IRON RIDGE SUBDIVISION FILING NO. 1 & 2

FINAL DRAINAGE REPORT

PCD FILE NO: SF2612 & SF2613
ALL TERRAIN ENGINEERING PROJECT NO: 25009
NOVEMBER 2026

PROPOSED DRAINAGE MAP

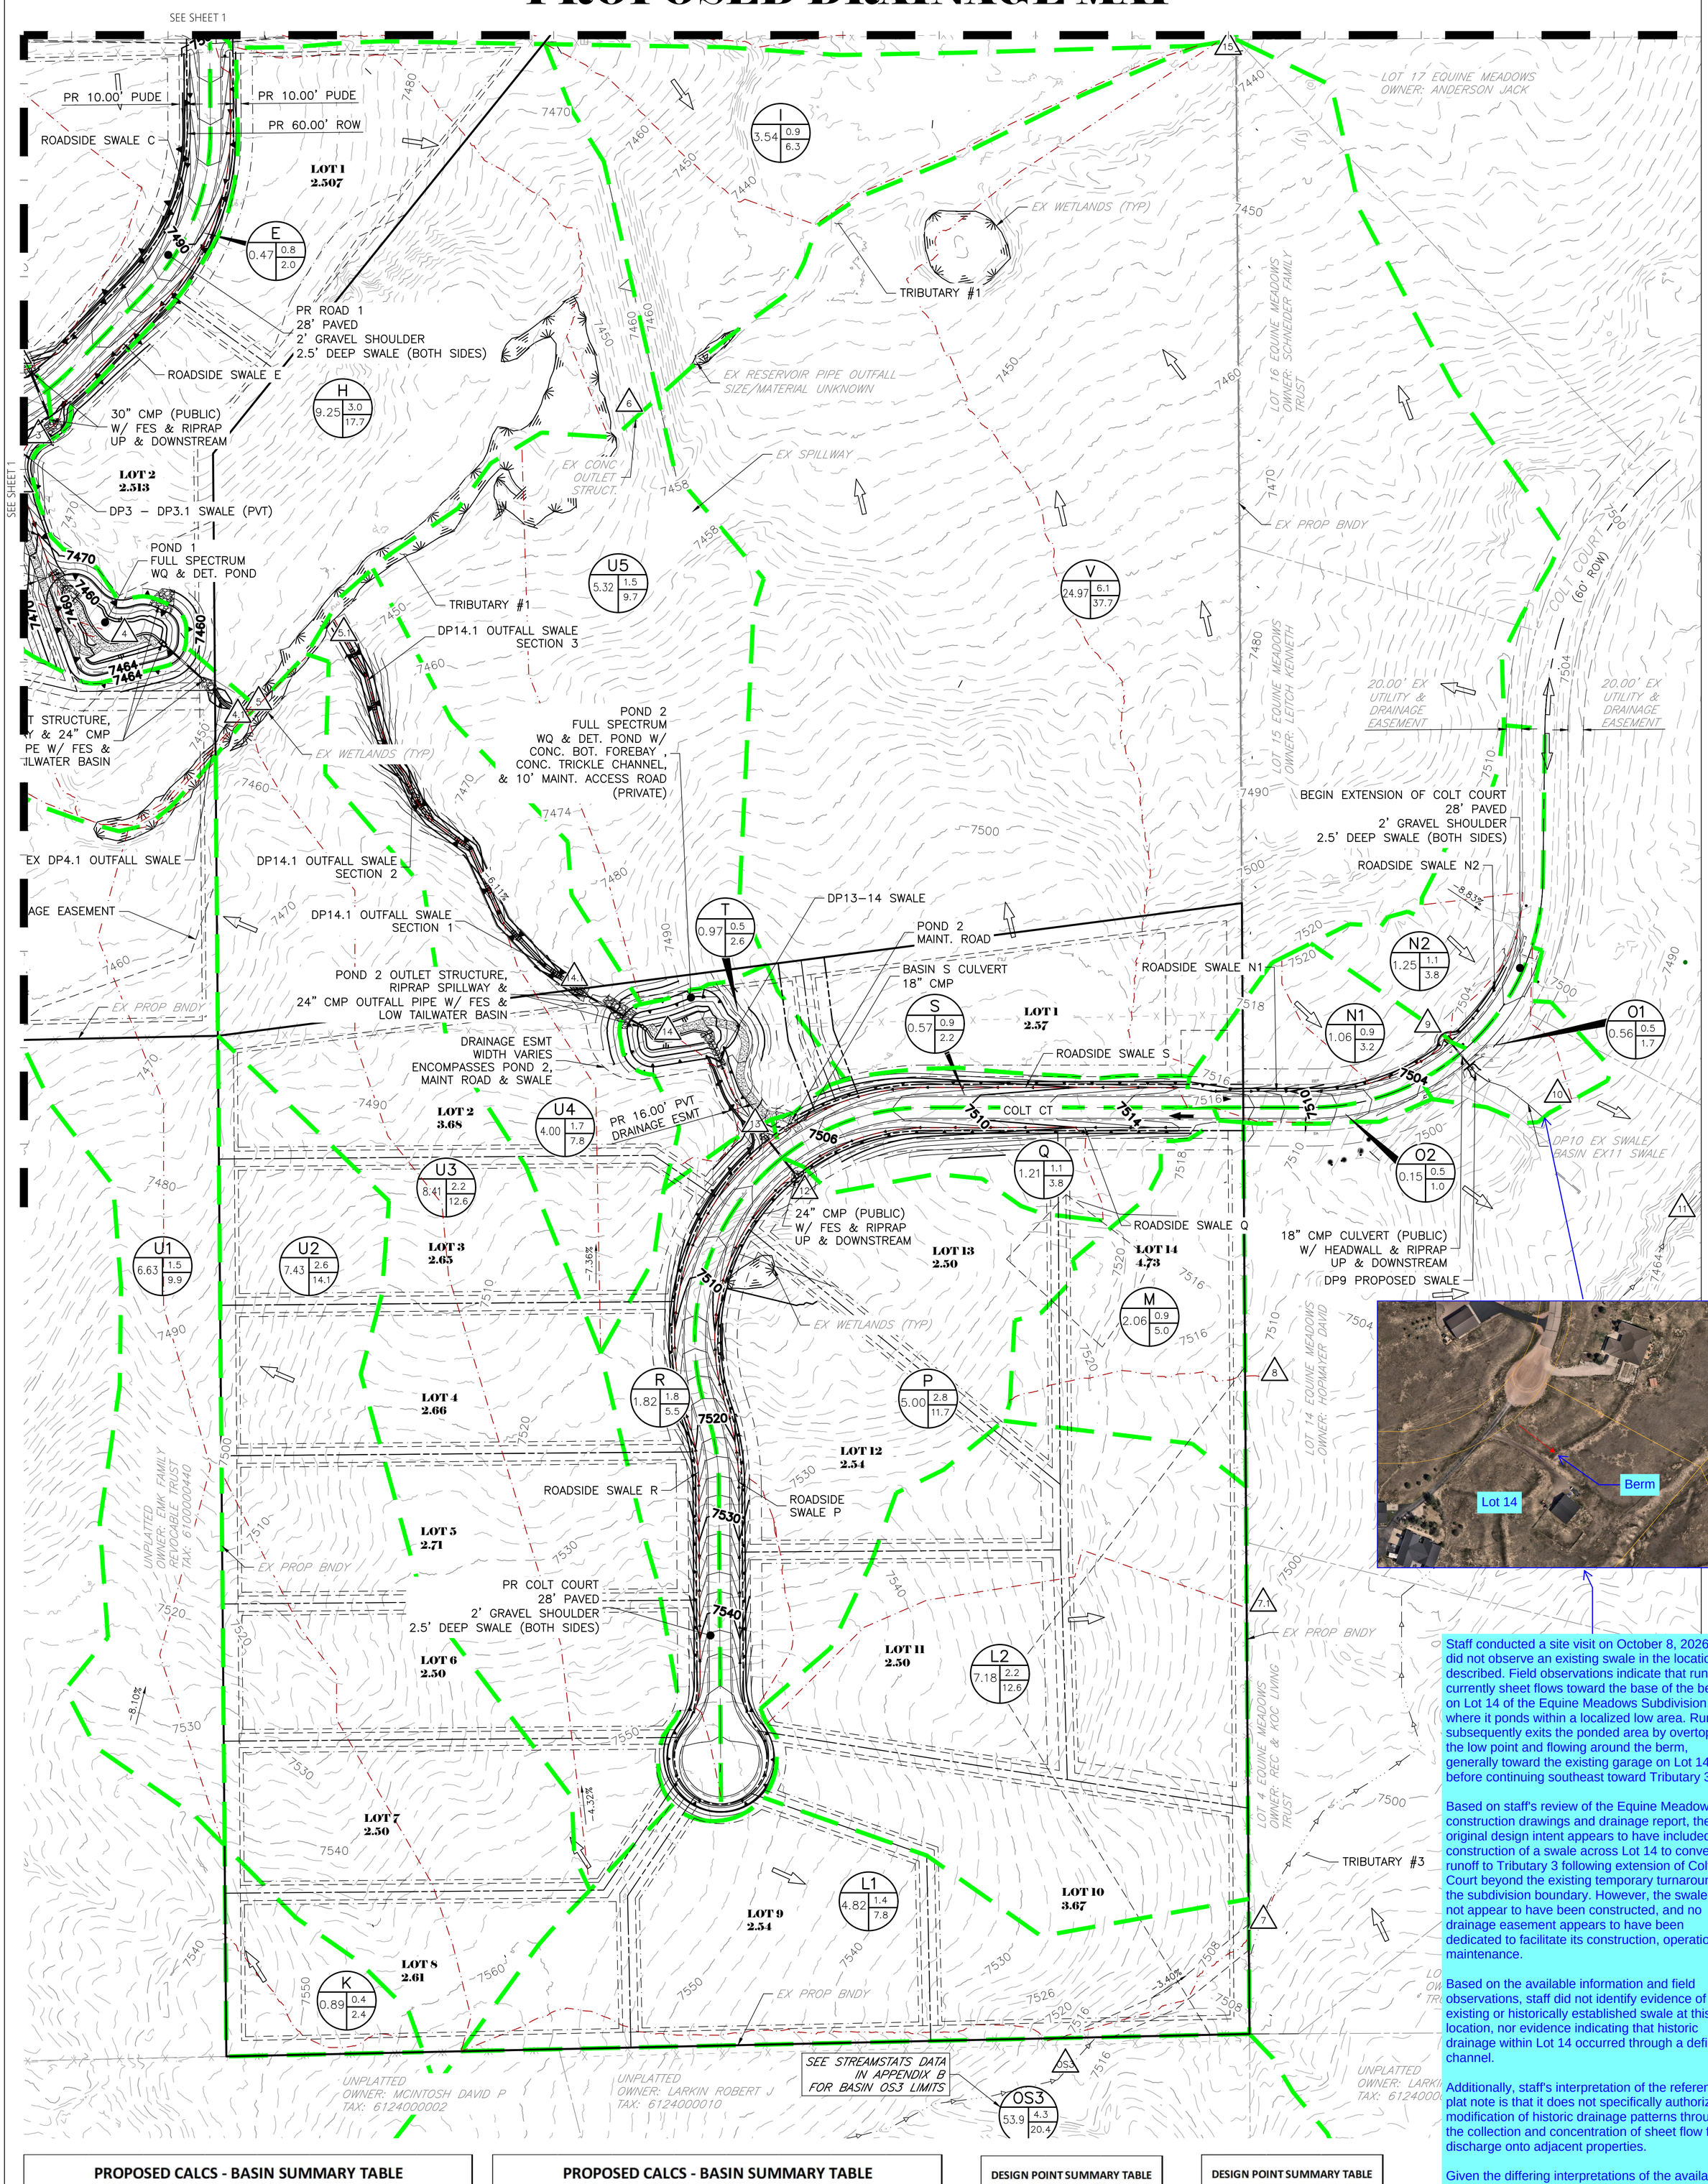
Please refer to comment provided on Proposed Drainage Map for Filing 2 at the end of this report.

Staff conducted a site visit on October 8, 2026, and did not observe an existing swale in the location described. Field observations indicate that runoff currently sheet flows toward the base of the berm on Lot 14 of the Equine Meadows Subdivision, where it ponds within a localized low area. Runoff subsequently exits the ponded area by overtopping the low point and flowing around the berm, generally toward the existing garage on Lot 14, before continuing southeast toward Tributary 3.

Additionally, staff's interpretation of the referenced plat note is that it does not specifically authorize modification of historic drainage patterns through the collection and concentration of sheet flow for discharge onto adjacent properties.

Please refer to comment provided on Proposed Drainage Map for Filing 2 at the end of this report.
